Detailed Site Plan Departure from Sign Design Standards Maryland 95 Corporate Park, Redevelopment of Lot 20

**DSP-98039-04
DSDS-25001**

STAFF REPORT

SUBJECT: Detailed Site Plan DSP-98039-04
Departure from Sign Design Standards DSDS-25001
Type 2 Tree Conservation Plan TCP2-2025-0071
Maryland 95 Corporate Park, Redevelopment of Lot 20

Figure 1: Front Elevation (Northeast)

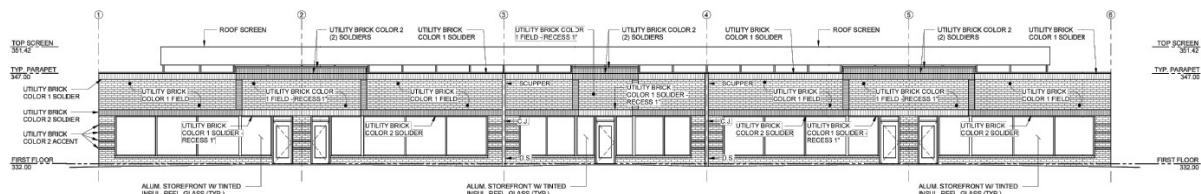
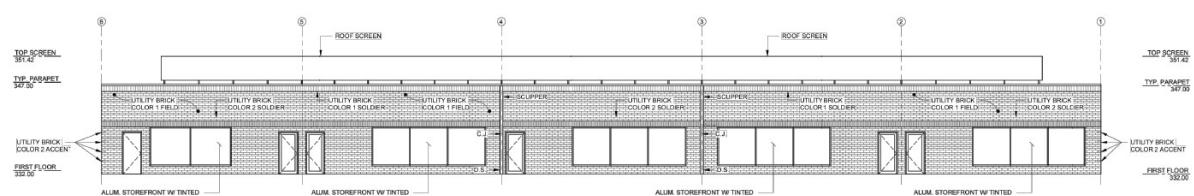
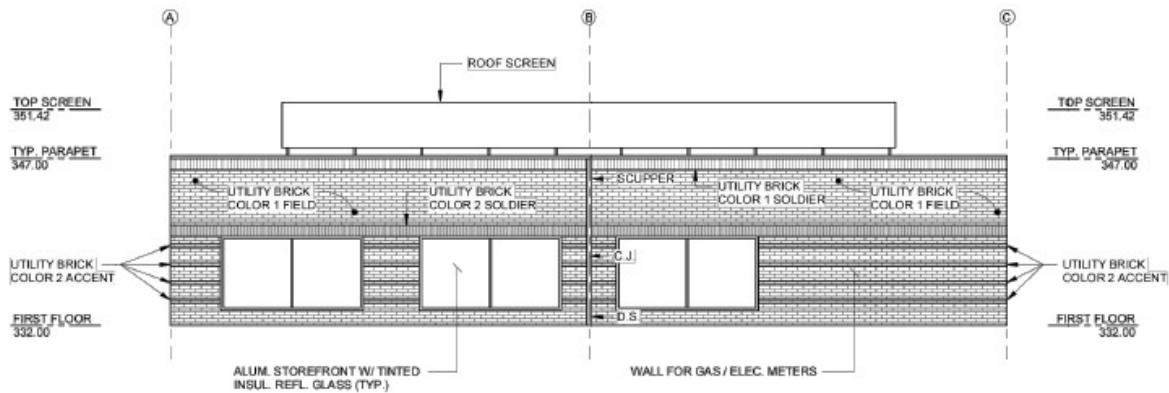
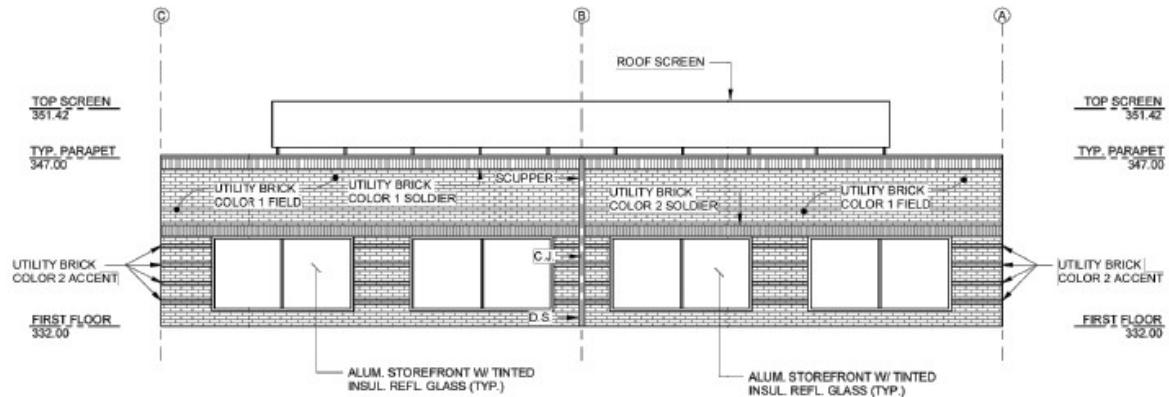
- a. Provide dimensions on elevations.
 - b. Provide location and details of the building-mounted light fixtures for the proposed day care center for children, in conformance with Section 27-562 and 27-274(a)(3)(A) of prior Prince George's County Zoning Ordinance.

Figure 5: Site Cross-Section Exhibit

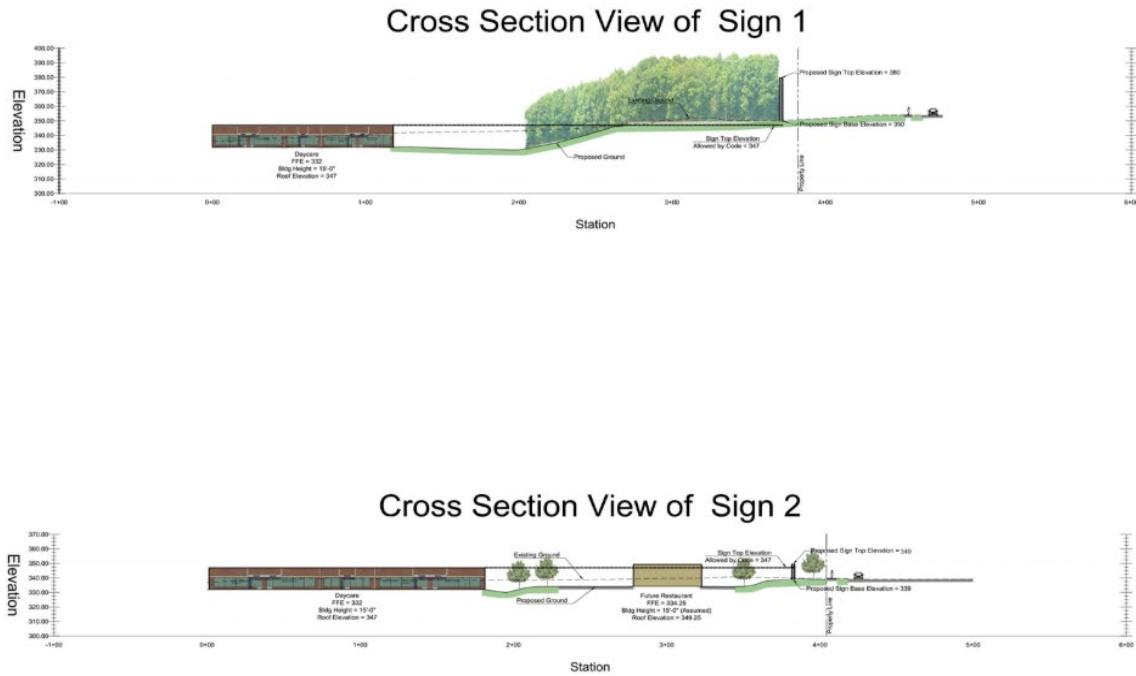
The applicant further asserts that the proposed 30-foot height of the Konterra Drive sign represents the minimum necessary to ensure adequate visibility and legibility of the sign, with the 40 mile per hour speed limit on Konterra Drive, distance of the sign from the roadway, and the existing tall vegetation to remain around the sign. Though Lot 22 does not actually abut Konterra Drive, due to the adjacent lot configuration, the applicant takes into consideration the "perceived" frontage, from both Sweitzer Lane and Konterra Drive. This perceived frontage takes into account the frontage along Sweitzer Lane and Konterra Drive, if not for the abutting lots which form a narrow strip of land between Lots 22 and the ROW. The site's topography creates a circumstance in which the elevation at the intersection of Sweitzer Lane and Konterra Drive is higher than the existing and proposed buildings, impeding upon the awareness and identification of the development from the intersection and, as the applicant believes, contributes to the vacancy of the existing office building in the development. Staff find that provided signage that departs from the standards represents the minimum necessary, given the specific circumstances of the request.

Based on the analysis above, staff recommend that the Planning Board approve DSDS-25001 for the proposed freestanding signage, which is designed at an appropriate scale for visibility and activation of the development.
